**SERVICE BULLETIN**  
**No BE-010/SZD-59/2009 „ACRO”**

**DESIGNATION-TYPE/MODEL:** SZD-59 „ACRO”

**CONCERNS:** Inspection of the fuselage frame joints.

**SERVICE BULLETIN**  
**No BE-011/SZD-59/2009 „ACRO”**

Fig.1. Cracks location.

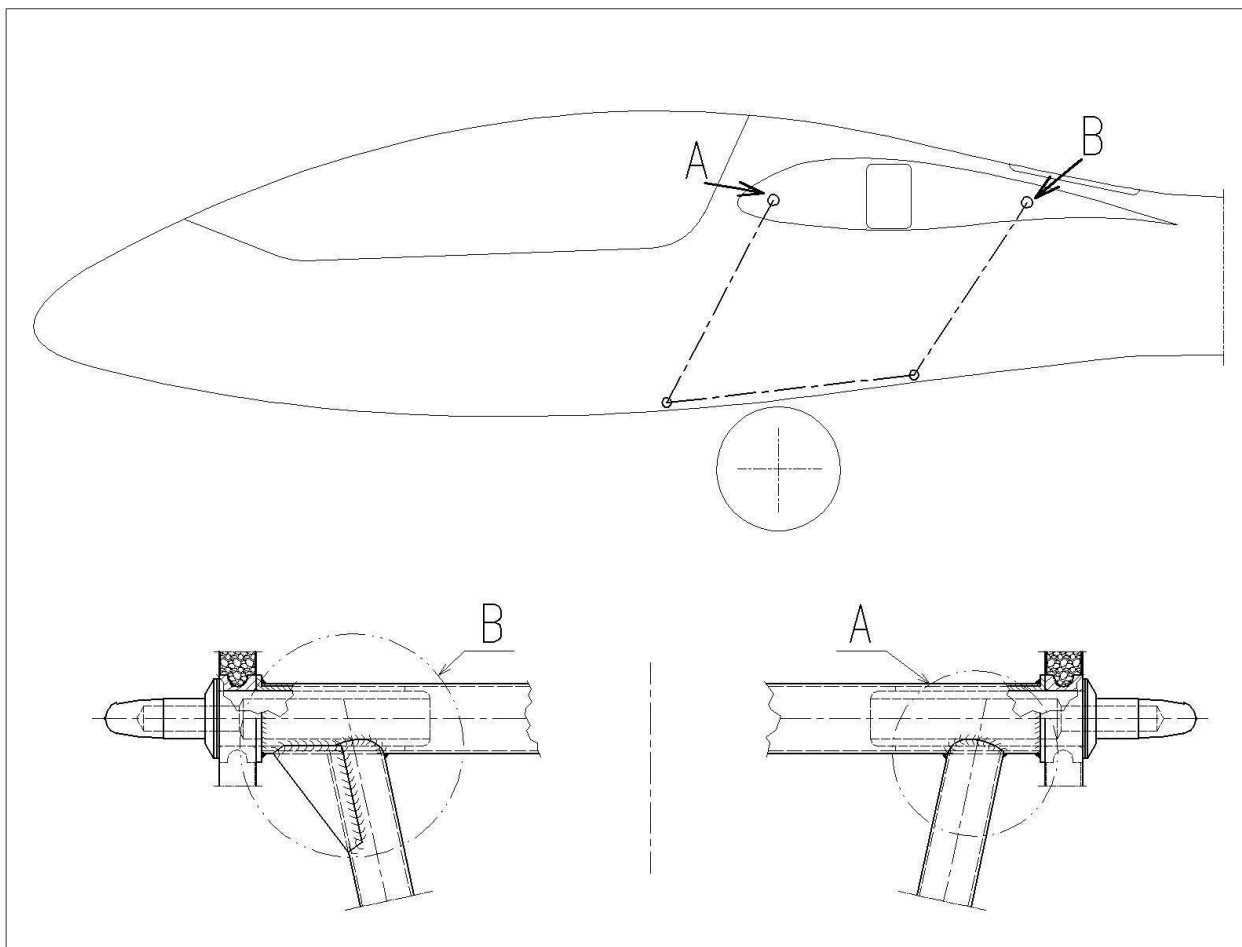
In 4 SZD-59 gliders a cracks of the fuselage frame tube has been detected, at the front wing fixing point, near welded joint.

By the cockpit's cutout the front frame tube at welded joints, next to the front wing fixing pivots (see Fig.1, A )is to be inspected by visual methods. All circumference of the tube is to be inspected. By the sighthole between wings, rear frame tube is to be inspected, at the welded joints (see Fig.1, B). All circumference of the tube is to be inspected. For rear tube inspection, tools like a digital camera, endoscope or similar can be necessary. In a case of a crack is found, the glider is to be found non-airworthy until a repair is done, and the operator of a glider is requested to report the case to the manufacturer. Please enclose following information: serial number of the glider, total flight time and total amount of landings.

5.1. The inspection of the front tube is to be repeated before every day of flying. The inspection of the rear tube is to be repeated after each 5 flying days.

**Fig.1.**

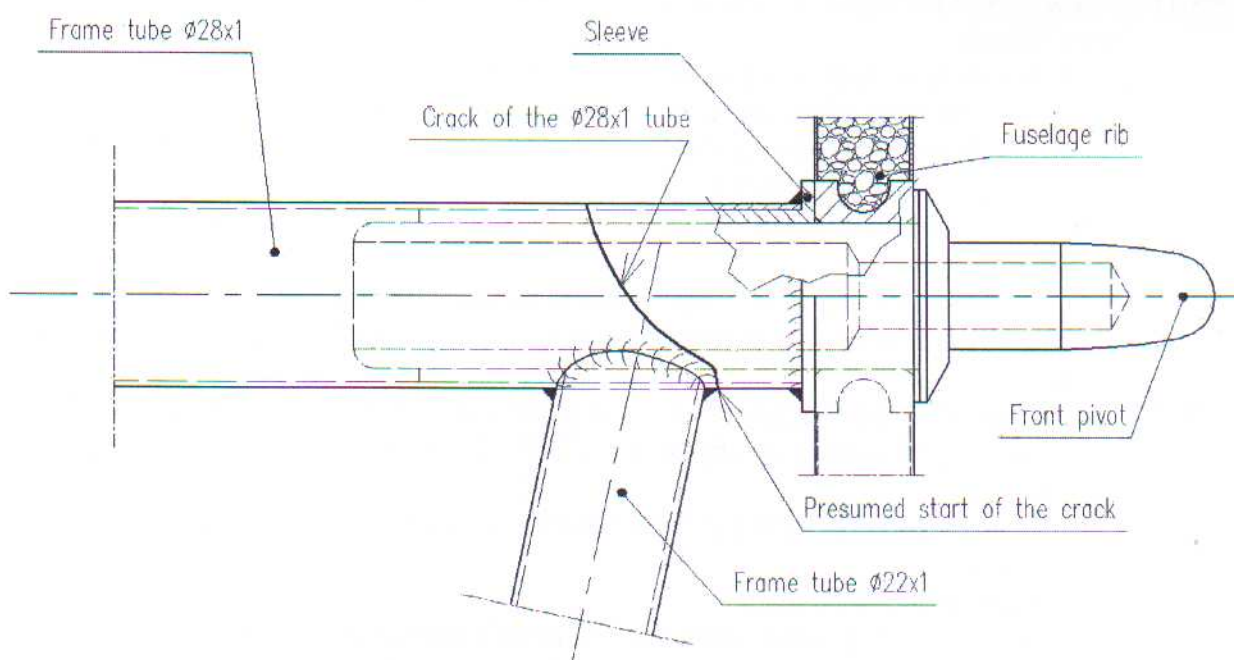
During the exploitation of gliders a fatigue crack of the left front welded joint of the fuselage frame had been detected. The crack is a result of presumed high stress level and intensive exploitation in aerobatics. Real stresses initiates the cracks which can, in extreme case, cover all the diameter of the outer tube (Fig.1.).

Fig.2.

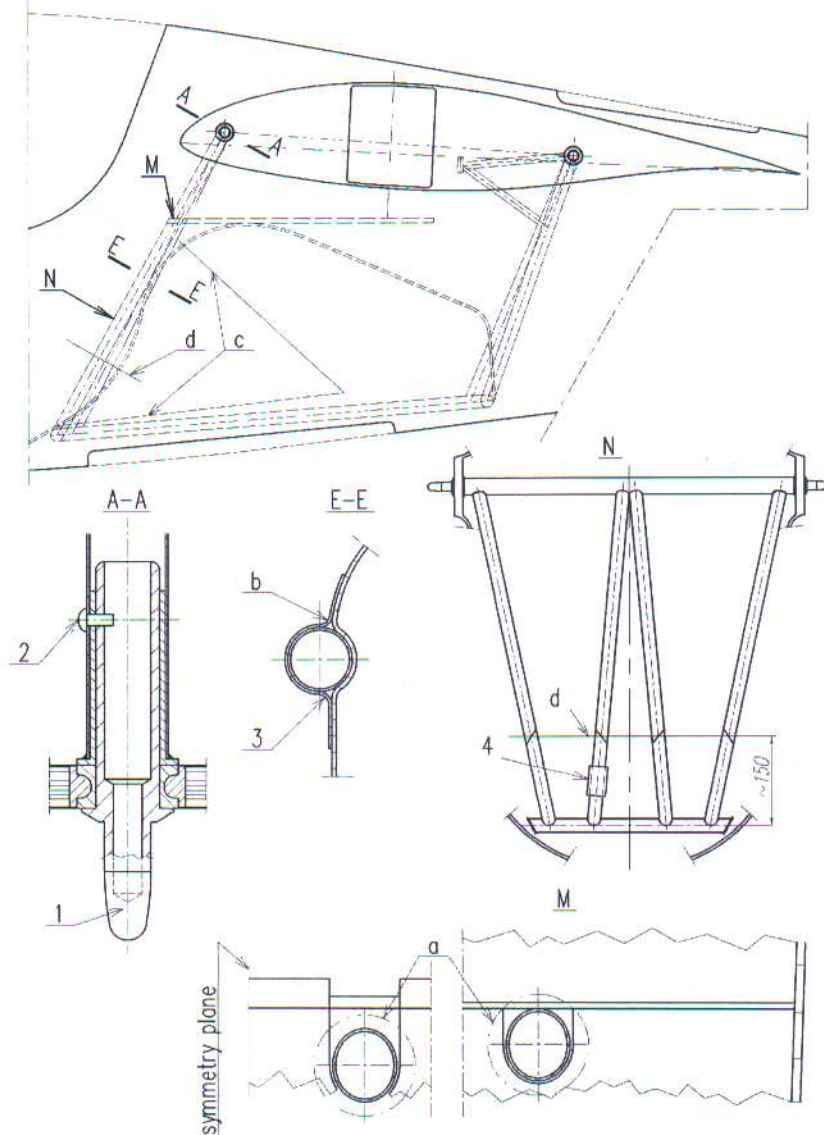
- 3.1. CG hook's control is to be disconnected.
- 3.2. Main wheel is to be dismounted.
- 3.3. Front landing gear leg is to be dismounted.
- 3.4. The composition from area (a) – Fig.2, detail M – is to be removed.

- 3.5. Straps (3) – made of 1x92110 fabric – are to be cut in the corners (b) of the landing gear box – Fig.2, section E-E.
- 3.6. For make welding easier, landing gear box is to be cut along (c) line – Fig.2.  
Cut off part is to be taken out.

- 3.7. The 4 diagonal tubes of the frame are to be cut at level (d) with angle ~45° – Fig.2.
- 3.8. The rivets (2) – Fig.2, section A-A – are to be drilled from head side with Ø4mm drill.

- 3.9. The pivots (1) – Fig.2 – are to be removed from the frame. The pivots are settled by H7/k5 fit, therefore adequate force is required to be used. In case of damage, the damaged pivot is to be replaced by a new one from the kit.

- 3.16. Holes Ø3,9mm for rivets (2) – Fig.2 – are to be drilled. Inner surface of the tube is to be preserved by anti-corrosive fluid by rivet holes. Steel rivets Ø4mm are to be driven into holes.

- 3.21. In the control table (4) – Fig.2. – a letter "R" is to be marked permanently, the control table is to be remounted by 2 AL blind rivets.

Fig.3.

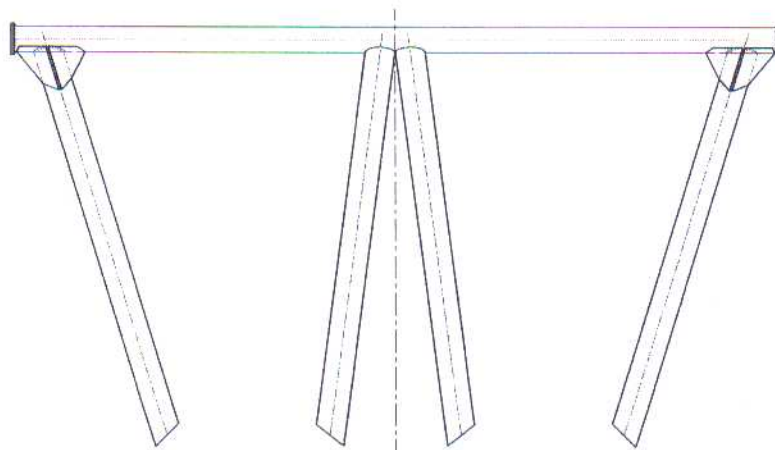
Part of the frame (Fig.3., according to sketch 590.12.00/BE-011) with aligning sleeves, one frame pivot and welding wire is being delivered by Allstar PZL Glider.
